Westinghouse  
Electric Company LLC

NRC-01-36

September 07, 2001

SUBJECT: CHANGED PAGES; LICENSE NUMBER SNM - 1107; DOCKET 70-1151

Figure 2.2

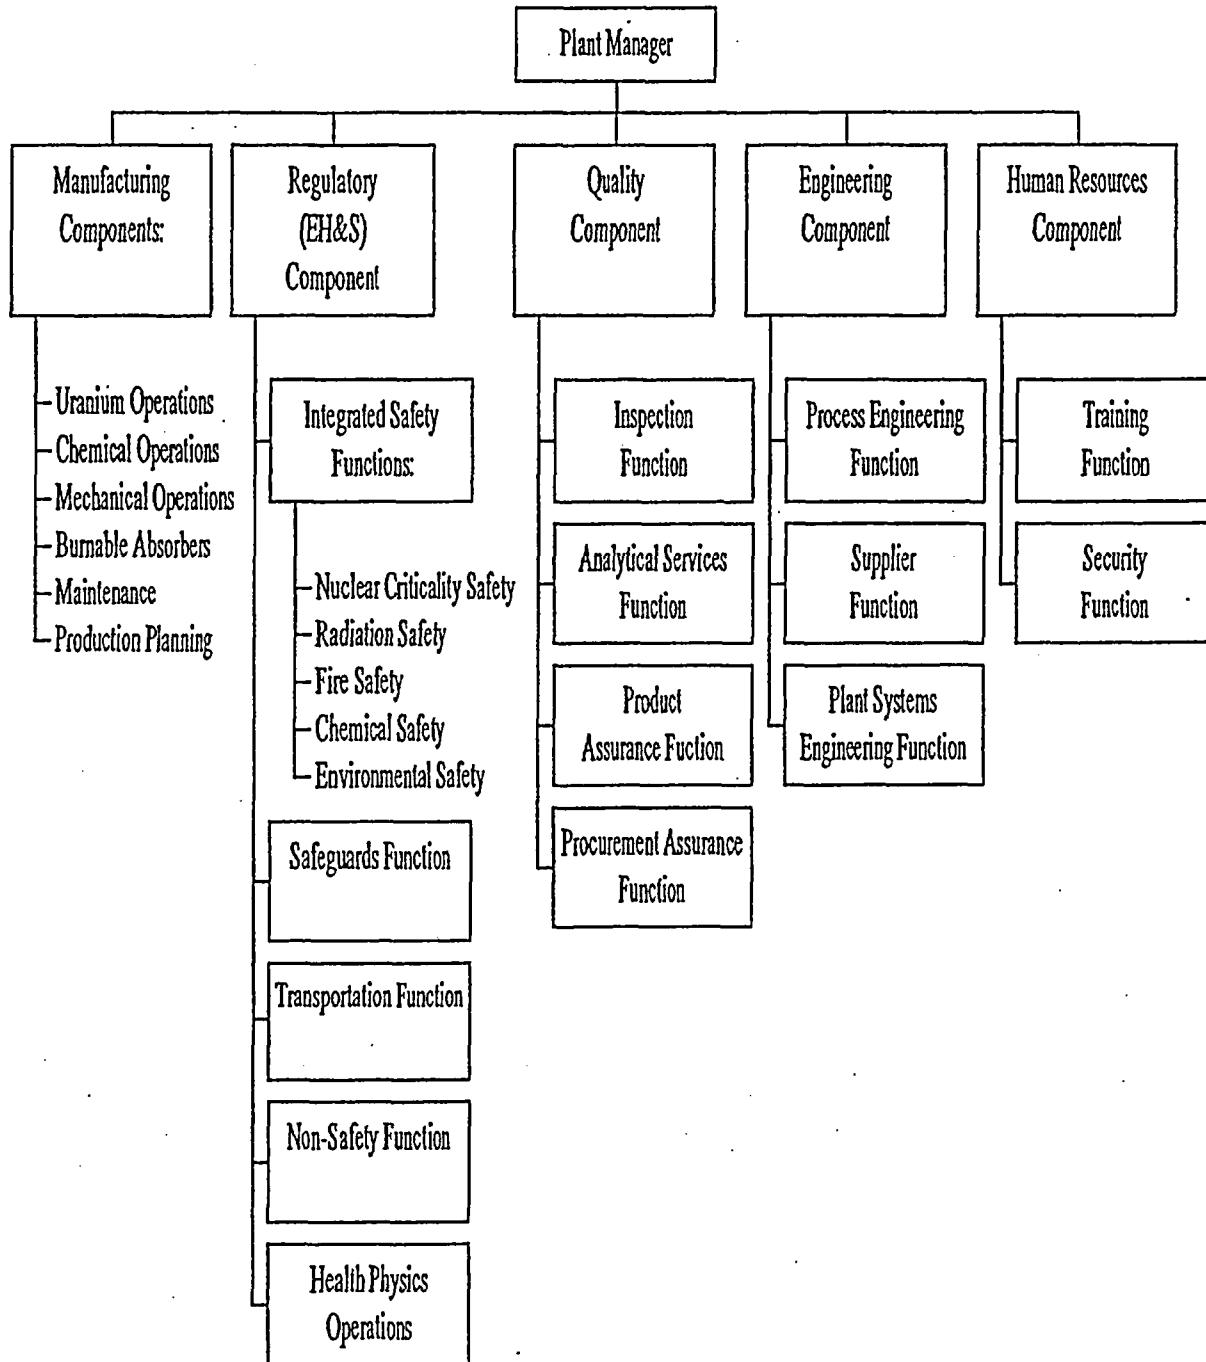
2. updated the organizational structure [page numbers 1.4, 1.5, 2.0, 2.2, 2.3, 2.5],
3. changed reference for additional corporate information to the worldwide web [page number 1.5],
